Generic Design Assessment – New Civil Reactor Build

Step 4 Electrical Systems Assessment of the EDF and AREVA UK EPR™ Reactor

Assessment Report: ONR-GDA-AR-11-023
Revision 0
10 November 2011

Figure 1: Schematic diagram of the connections between the two unclassified electrical buildings (UEB) on the conventional island and the four divisions on the nuclear island

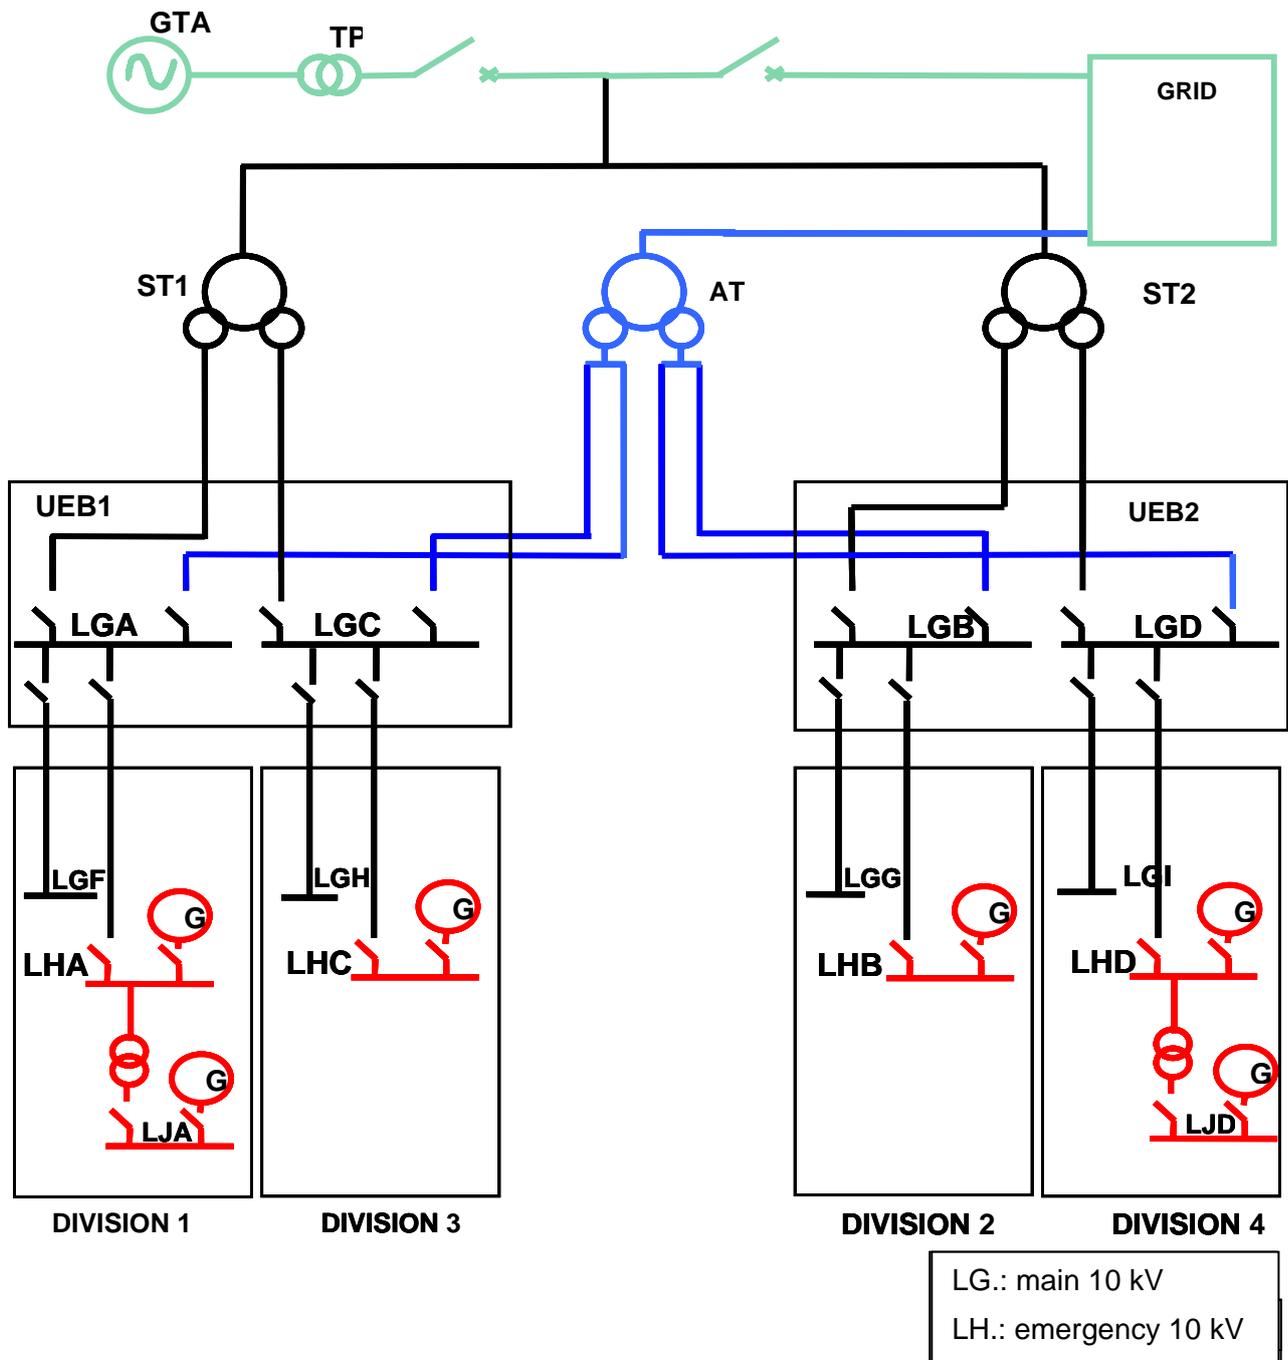
19 An overview of the Electrical Supply System is shown in Figure 1. The output from the Main Generator is connected to the 400kV Grid Substation with a tee off from this connection to two Step-down Transformers ST1 and ST2 which provide power to the Plant Electrical System at 10kV. A Standby Transformer AT provides an alternative supply from the Grid Substation in the event of loss of supply from ST1 or ST2.

- 25 The basic structure of the Plant Electrical System is robust and suitable for providing the power supplies required to maintain the reactor in a safe condition under a wide range of operating and fault conditions. The structure of the system meets the requirements of the Safety Assessment Principles (SAP) (Ref. 4).
- 26 I consider the arrangements to be acceptable for maintaining connection during dips in main supply voltage.

Figure 2: Currents flowing through ST and AT at LV side during the switchover

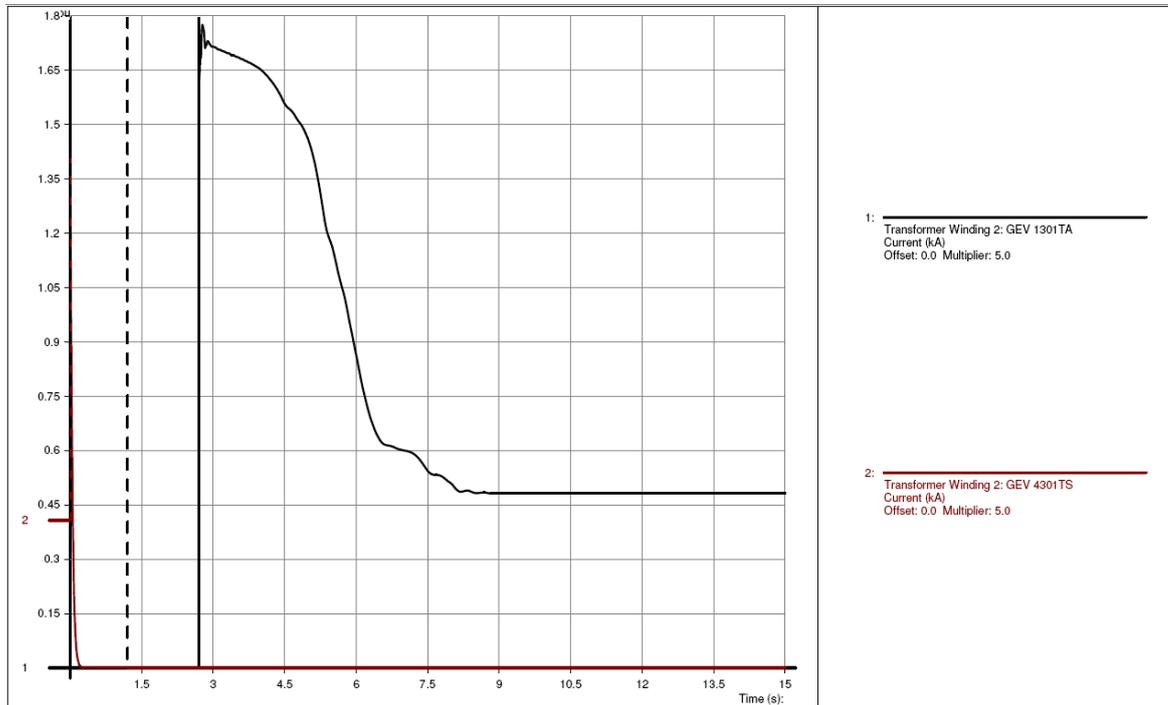
147 Currents flowing through ST and AT on the LV side during the switchover with respect to time are plotted in Figure 2. The short circuit is applied at time zero. The first almost vertical dotted line shows when the short circuit is removed after 1.2s and the ST circuit breaker opened. The second almost vertical line shows when the AT supply is applied. At 2.7 seconds (1.2s for fault duration + 1.5s for delay after ST opens), the circuit breaker supplying the system from AT is closed and the motors are re-started.

148 An objective of the preventive changeover is to react to the transient voltage reduction and achieve the changeover from ST to AT without starting the EDG. The criterion to achieve this is that the voltage at the diesel generator switchboard should recover above 80% in 5s. Figure 3 shows the voltage at each busbar, recovering to within 80% of nominal in approximately 5 seconds. The important point to observe is that the voltage recovery occurs and shows no tendency for motors to stall. This recovery time is greater than that shown in EDF document ENSEMD090232 (Ref. 23) due to different load inputs being applied to the model so considers a more onerous case. This shows that the system is robust and recovery is assured.

Figure 3: Voltage Recovery at Each Busbar after Switchover from ST to AT

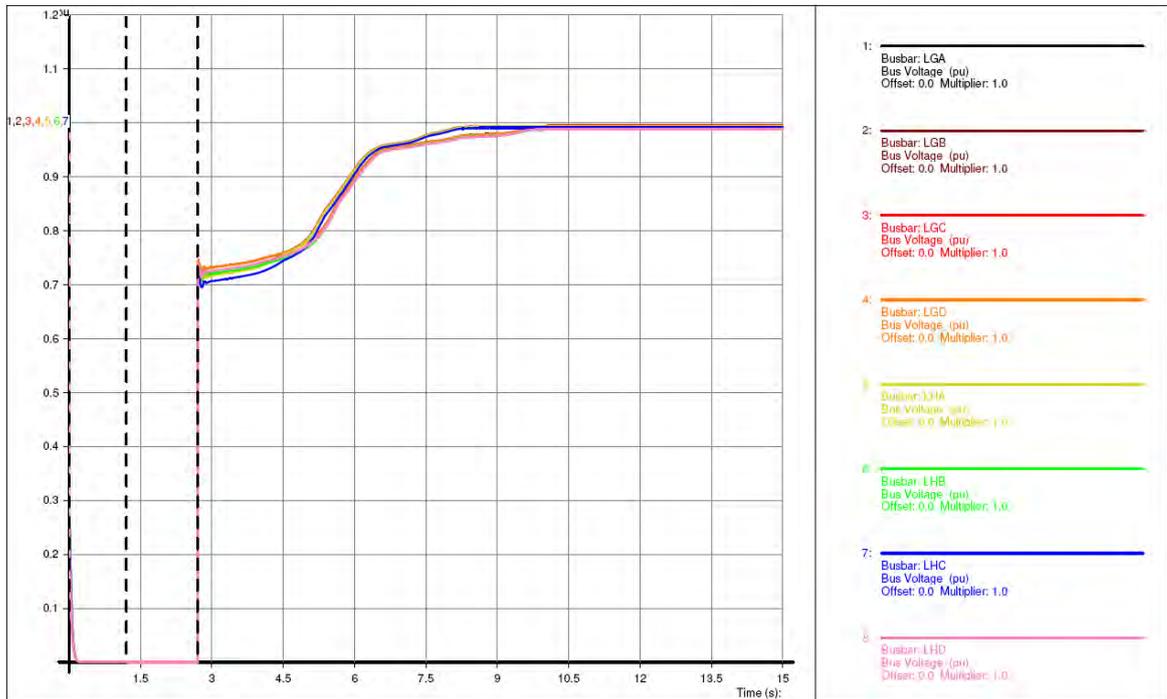
- 152 The study was conducted to examine if the system could recover during the switchover from ST to AT. The simulation sequence used in the document ENSEMD090232 (Ref. 23) was applied. The study results show that the voltage recovers and there is no tendency for motors to stall. I consider that this shows the system to be robust and recovery is assured.

Figure 4: Voltage Recovery at Each Busbar after a 1.19s Three Phase Fault Is Cleared and the Grid Coupling Circuit Breaker Is Opened During the Fault

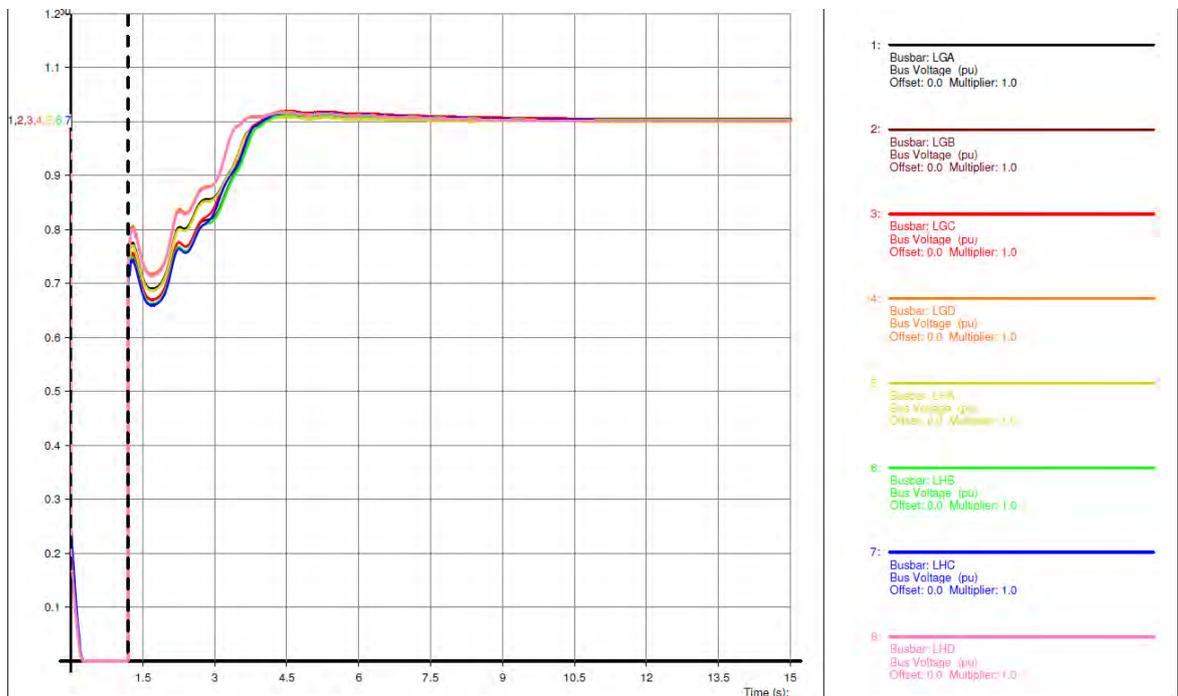
- 151 The voltages at LGi and LHi are shown in Figure 4 for a solid three-phase fault at ST HV terminals lasting for 1.19s with the grid being disconnected and leaving the main alternator supplying the nuclear power plant. The results of this study are as follows:

- 155 The voltage on all busbars is zero from the time of the short circuit fault to switchover to the AT transformer at 2.7s after fault initiation. The motors do not sustain significant system voltage during this period. Voltage recovery after switchover to 90% of nominal levels is further delayed by motor acceleration currents and is in the order of 3.1s to 3.4s. These are predictable trends that verify the system is operating in a stable manner.

Figure 5: Results for Scenario 1 of House Load Operation at 100% Power

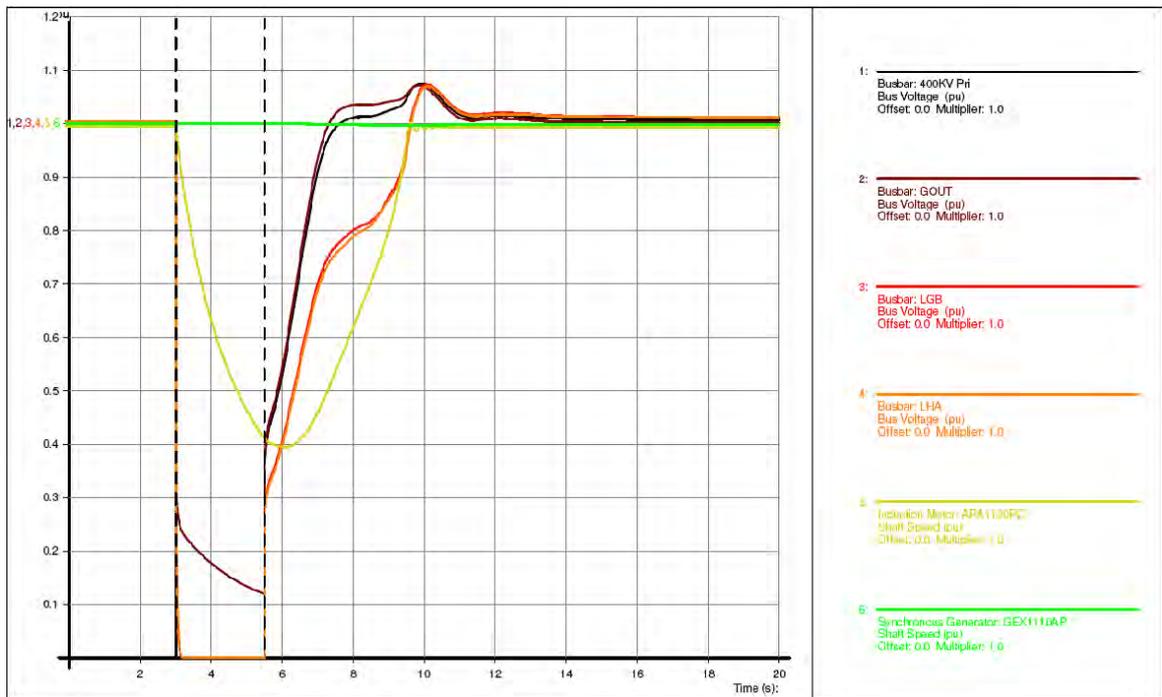
- 175 Figure 5 shows for Scenario 1, that the voltage remains under $1.1 U_n$.
- 176 Figure 6 shows for Scenario 2, that the main alternator voltage is within the upper limits of the accident range of $1.1 U_n - 1.4 U_n$ for 2.1 seconds. The other calculated voltages for the 10kV switchboard and the LV switchboards also rise to within the $1.1 U_n - 1.4 U_n$ range but for a shorter time of less than 1 second.

Figure 6: Results for Scenario 2 of House Load Operation at 100% Power

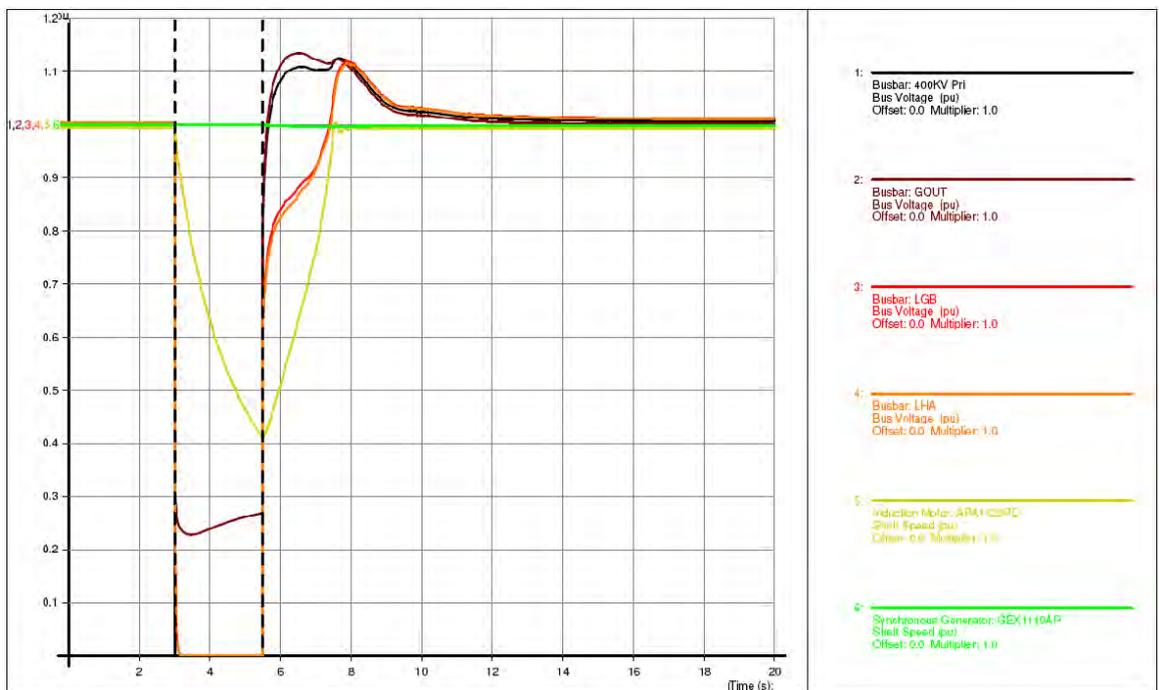
- 177 The voltage of switchboards LGB is less than $0.7 U_n$ for less than 3.5 s. Therefore, ST to AT switchover will not be initiated. The voltage of the emergency supplied switchboards LHA is not less than $0.8 U_n$ for more than 5 s, so the emergency diesel generators (EDG) will not start-up.
